[Upgrade to Revision]

R20TS1093EJ0100

e² studio RX Smart Configurator Plug-in 2025-01,
Smart Configurator for RX V2.24.0

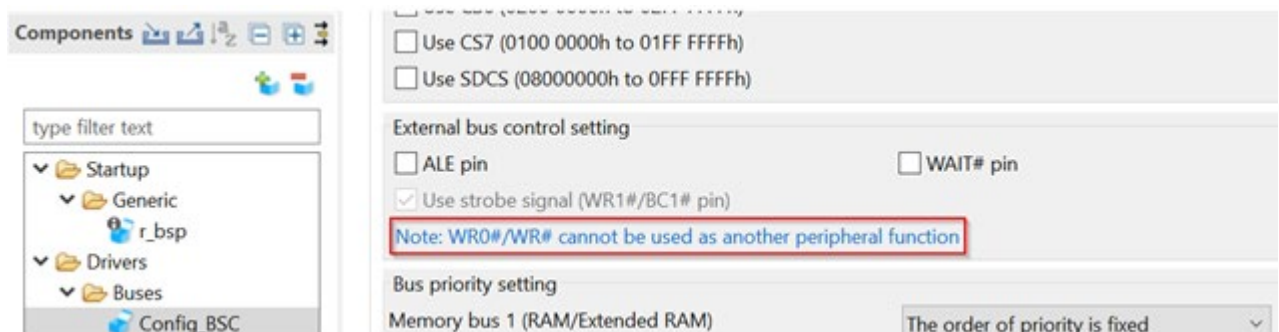
- Using Visual Studio Code with VS Code Debug Extension for Renesas GDB v25.2.1 or later, projects generated with the Smart Configurator can be easily built on VS Code using Ninja.

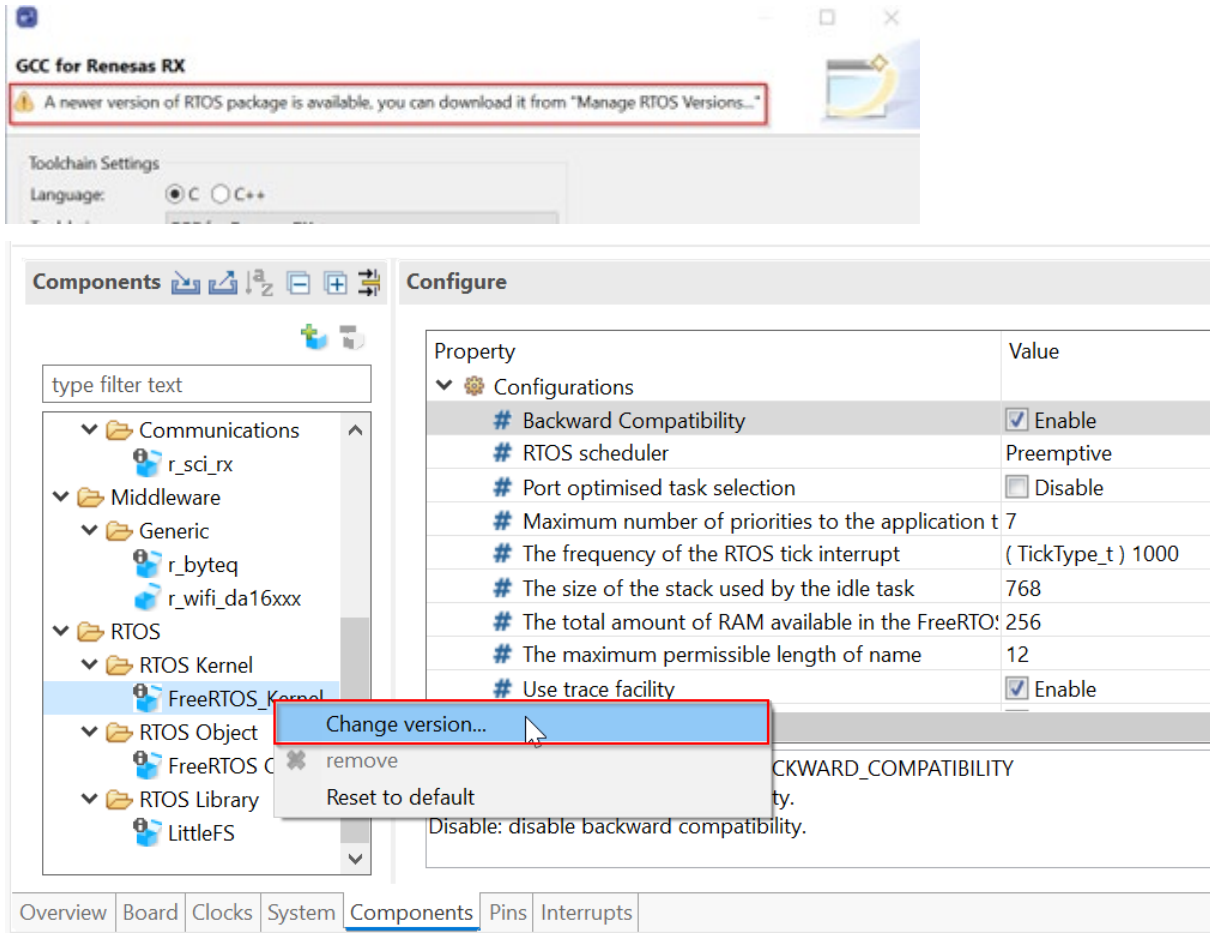
- When using the bus component, there is a warning message for WR# pin. Applicable devices: all RX600, RX700 devices, and RX230, RX231

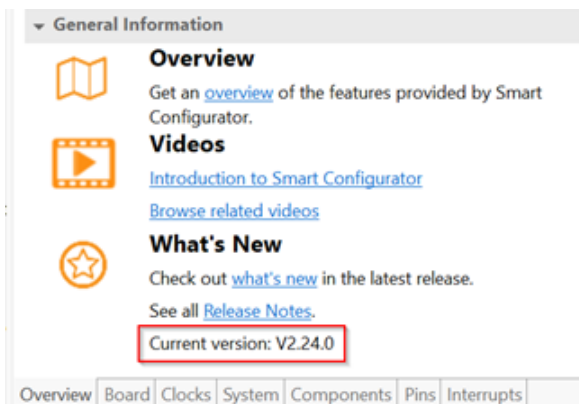
- Added magnet sensor (analog output) setting to the RX24T motor component.

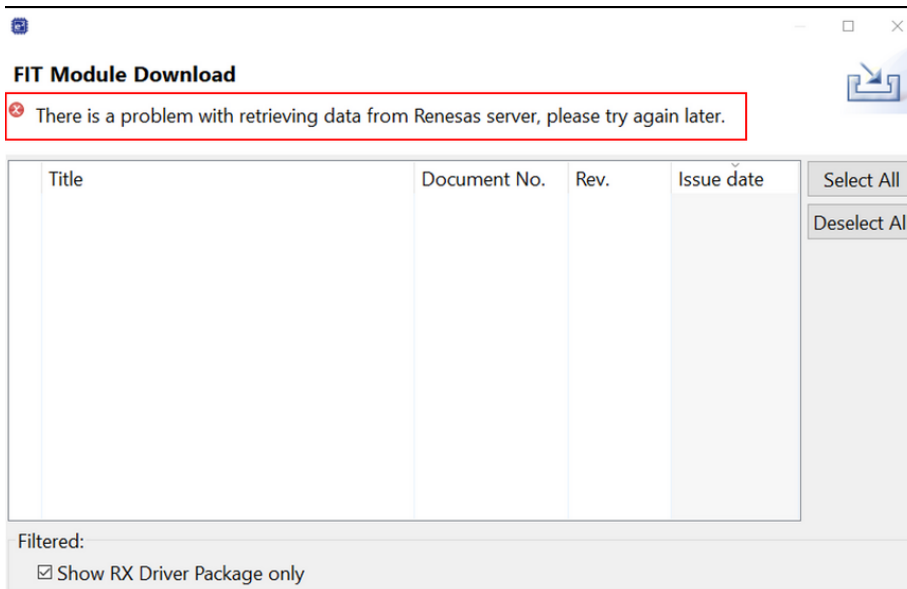
- Smart Configurator versions are displayed in the "Overview" tab.
